CAIRNGORMS NATIONAL PARK AUTHORITY

Title: REPORT ON CALLED-IN PLANNING APPLICATION

DEVELOPMENT PROPOSED: ERECTION OF 22 HOUSES AND CONSTRUCTION OF ACCESS ROAD ON LAND SE OF MILLSIDE HOUSE, MILTON, AVIEMORE

REFERENCE: 10/062/CP

Fig. 5- Layout of 22 houses proposed by this application

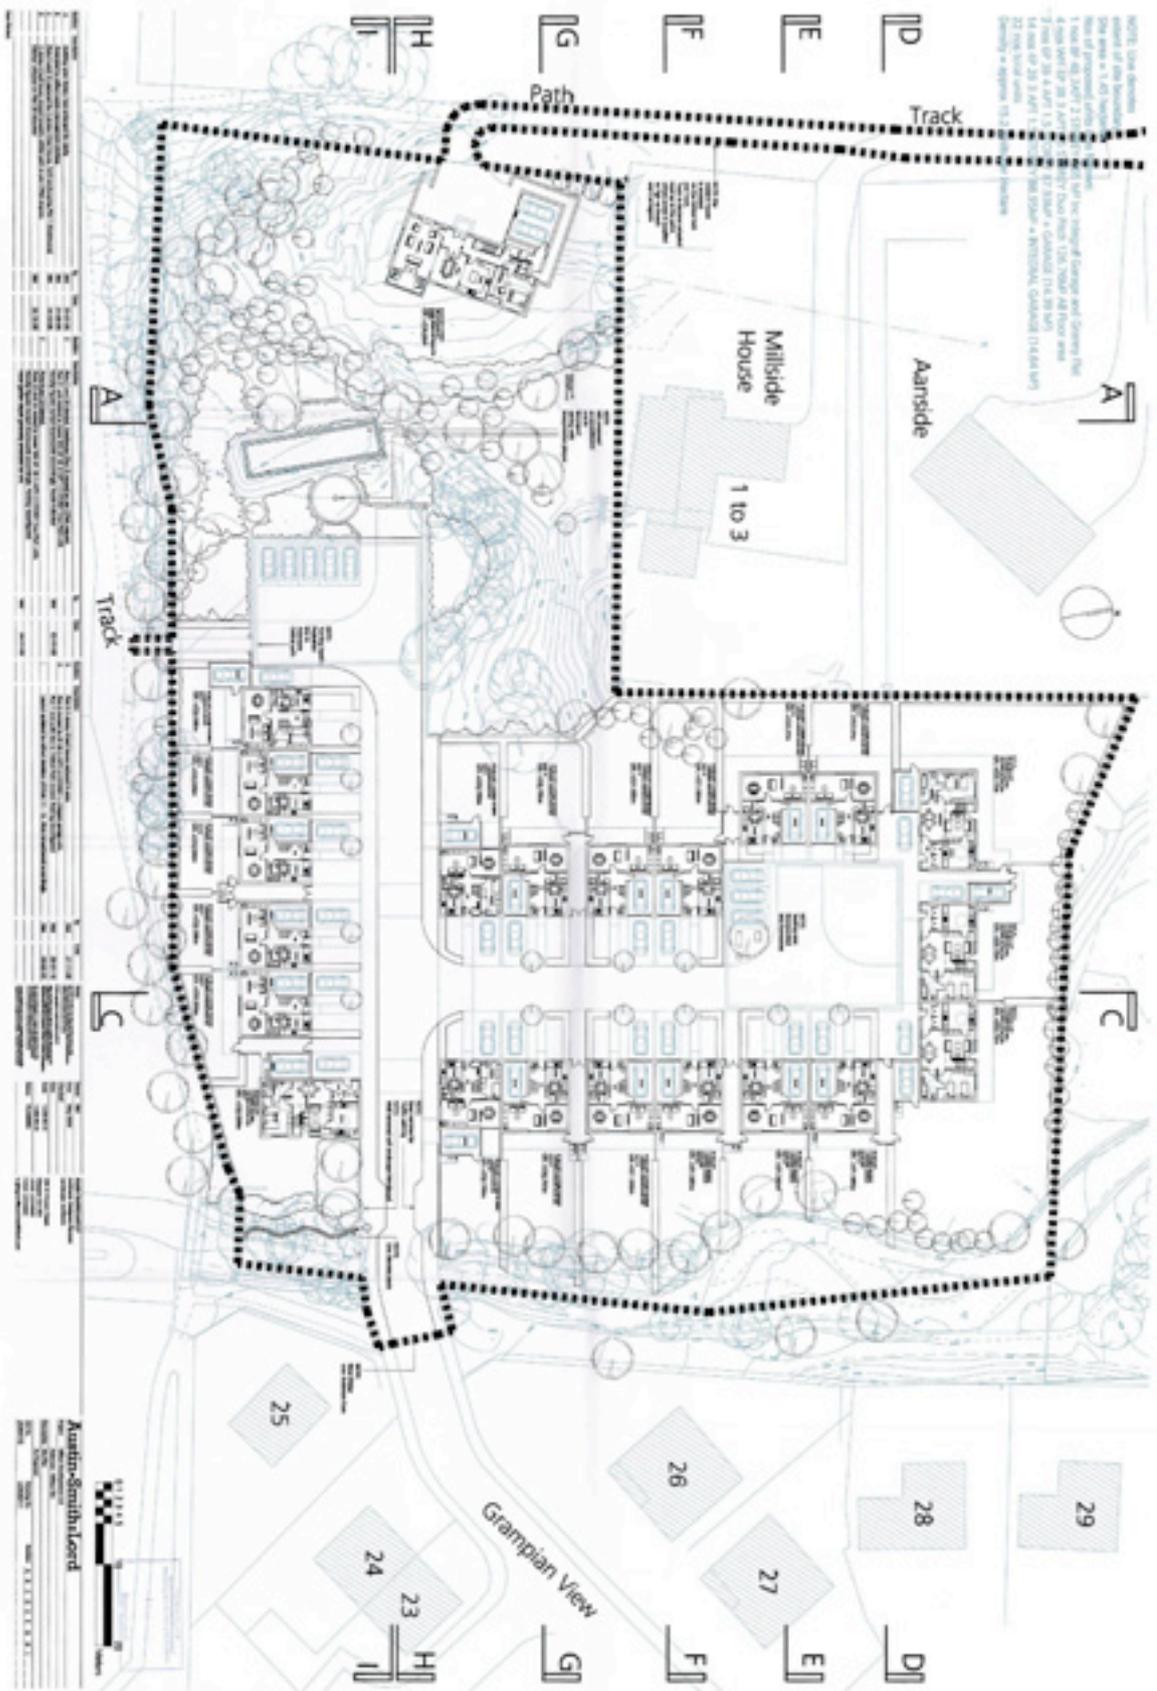
55. **Aviemore Community Council** has been consulted upon the application and has made more expansive comments than that for the previous application for 25 units. The Community Council object to the application considering that the proposal does not fulfil the requirements of the Badenoch and Strathspey Local Plan. The Community Council quotes an objector to the 2004 outline planning application for 21 houses on the site who is the current developer for the site.

56. Concerns are raised regarding density and that the density of housing quoted at 15.7 per hectare is misleading as it is based upon the whole site including parts that cannot be built upon. The density of the area to be developed is approximately 21.5 units per hectare. The proposed development is tight and enclosed where the north part of the village on this side of the road is characterised by larger houses with good garden space. The proposal is also considered to have a detriment to the amenity of houses to the north and north west of the site.

57. Concerns are raised about parking and that it will be difficult for vehicles to enter and leave each plot independently. Garage spaces may also be used for storage reducing the number of parking spaces. Additional parking is proposed for visitors to the Mill. This will result in the loss of the pond and stream. Encouraging this parking to be used by visitors to the Mill is not sustainable visits on foot and by cycle should be encouraged. The question is asked whether this parking is to make up for poor provision elsewhere.

- Condition set out at the outline for affordable housing needs to be strictly applied.
- Concern about upper house, plot 7, will be an imposing house that will stand above the archaeological site

62. As noted in the first part of the report the CNPA refused an application for 25 houses on this site in February. The reasons related to over development and the effect of plots 11-13 on the character and amenity of the area. An additional reason for refusal related to the effects of the drainage proposals for plots 11-13 on the character of the area. This amended proposal addresses the reasons for refusal by the removal of plots 11-13 (see figs 5 & 13)
